IN THE DRAWINGS:

REMARKS

ANNOTATED SHEET SHOWING CHANGES

FIG. 1

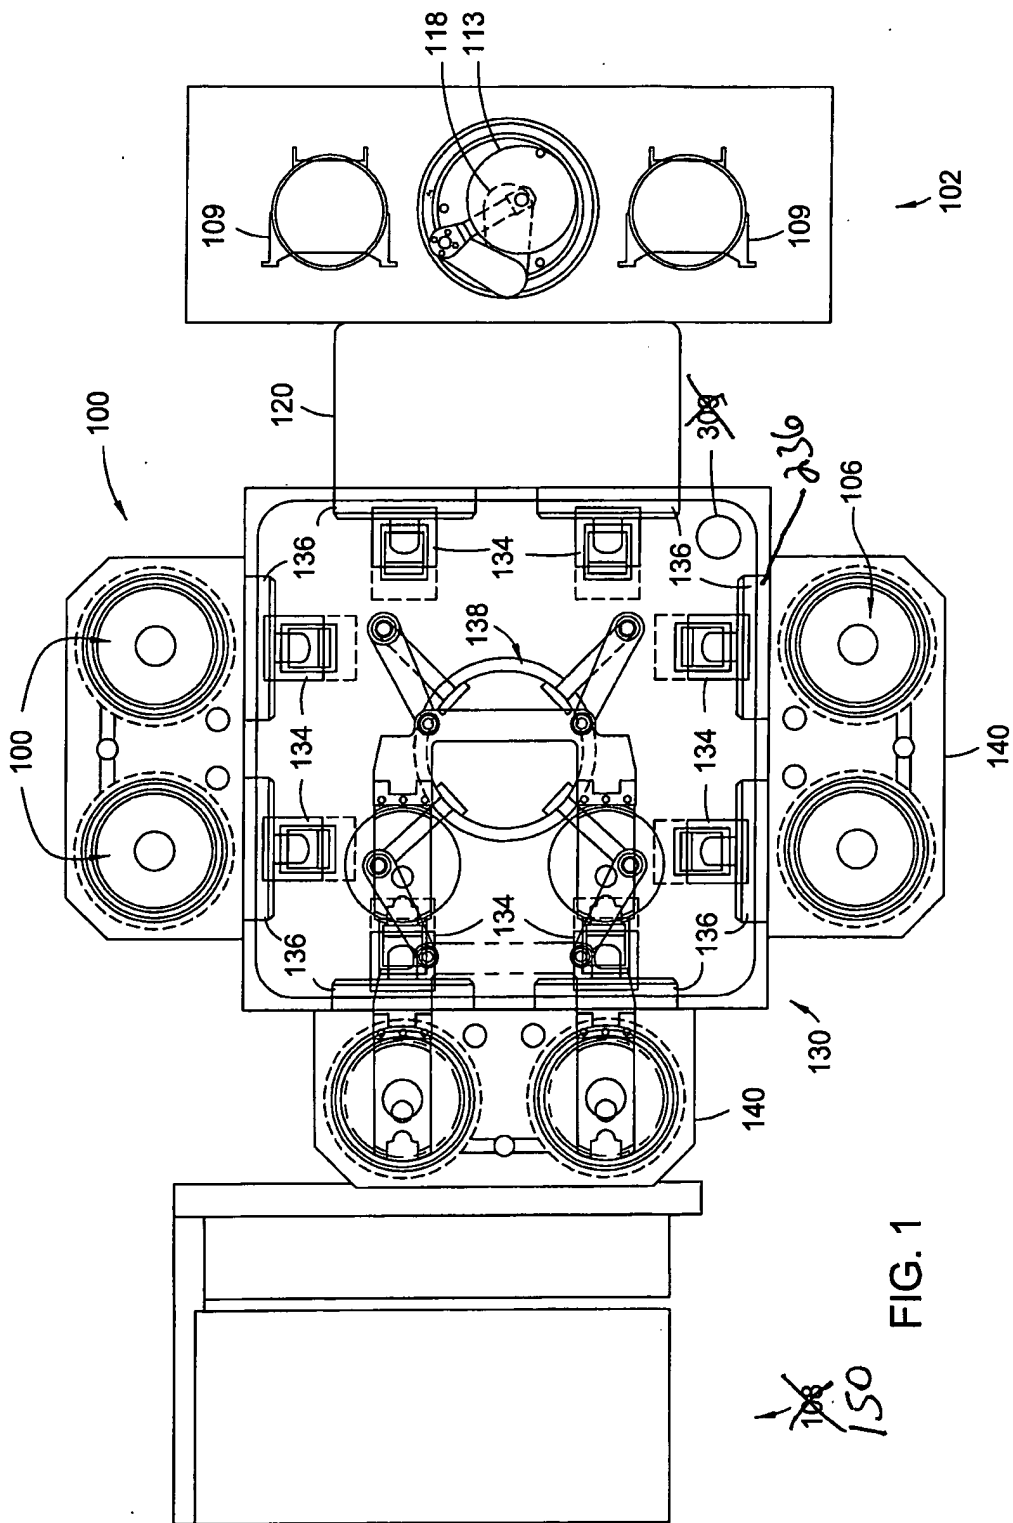
The attached two sheets of drawings include changes to Figures 1 and 6B. These sheets, which includes Figures 1 and 6B, replace the original sheets including Figures 1 and 6B. In Figure 1, previously omitted element 236 has been added, element 309 has been deleted, and element 108 has been changed to 150. In Figure 6B, an extraneous element 422 has been deleted.

In amended Figures 1 and 6B, the previously omitted element numerals 150 and 236 have been added, while extraneous element numerals 309, 108, and 422 have been deleted.
